Access Compliance Report

Public Rights-of-Way

(Curb Ramps)

Intersection ID: 42985	Main Street: BESSANT_CT	Cross Street: CHOWNING_TAVERN_LN	Location: E
ADA ID: FC76FCD64320	Ramp Type: PerpDiag	Initial Pass/Fail: Fail	Overall Compliance: No
Severity Score: 8.75			
Codes/Mitigation Info/Possible Solution		Field Measurements/Component Compliance

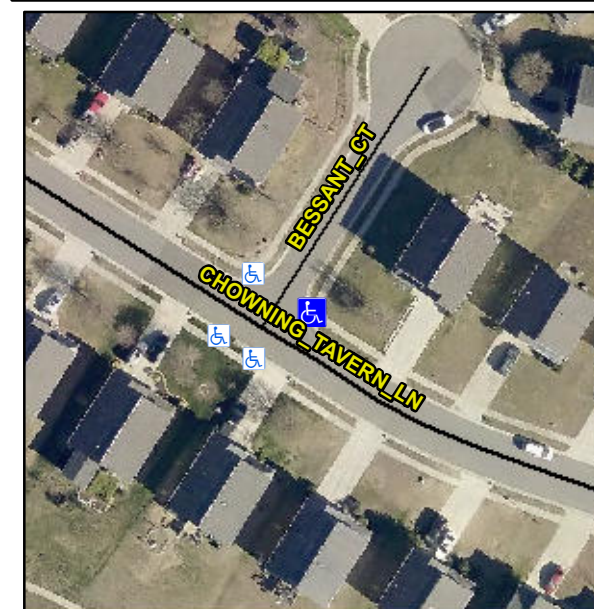
Not Found, R304.5.1

Compliance	Description	Data	Compliance	Description	Data
N/A	Ramp Length (in)	48.0	Yes	Ramp Slope (%)	6.1
No	Ramp Width (in)	38.0	Yes	Ramp XSlope (%)	0.7
N/A	Flare Type LT	N/A	N/A	Flare Type RT	N/A
N/A	Flare Slope LT (%)	N/A	N/A	Flare Slope RT (%)	N/A
N/A	Flare Traversable LT?	N/A	N/A	Flare Traversable RT?	N/A
N/A	Landing Length (in)	N/A	N/A	DWS Provided?	N/A
N/A	Landing Width (in)	N/A	N/A	DWS Contrast?	N/A
N/A	Landing Slope (%)	N/A	N/A	DWS Length (in)	N/A
N/A	Landing X Slope (%)	N/A	N/A	DWS Full Width?	N/A
N/A	Landing Curb? (Y/N)	N/A	N/A	DWS Offset (in)	N/A
N/A	Shared Landing?	N/A			
N/A	Gutter Ponding?	N/A	N/A	Gutter Slope (%)	N/A
N/A	Gutter Lip Ht (in)	N/A	N/A	Gutter X Slope (%)	N/A
N/A	Painted X Walk1?	No	N/A	Painted X Walk2?	No
	X Walk 1 Direction	To NW		X Walk 2 Direction	To SW
N/A	X Walk 1 Width (in)	N/A	N/A	X Walk 2 Width (in)	N/A
	X Walk 1 Slope (%)	1.9		X Walk 2 Slope (%)	1.9
	X Walk 1 X Slope (%)	2.4		X Walk 2 X Slope (%)	2.6

Remove & Replace Curb Ramp With Two New Directional Ramps or Equivalent.
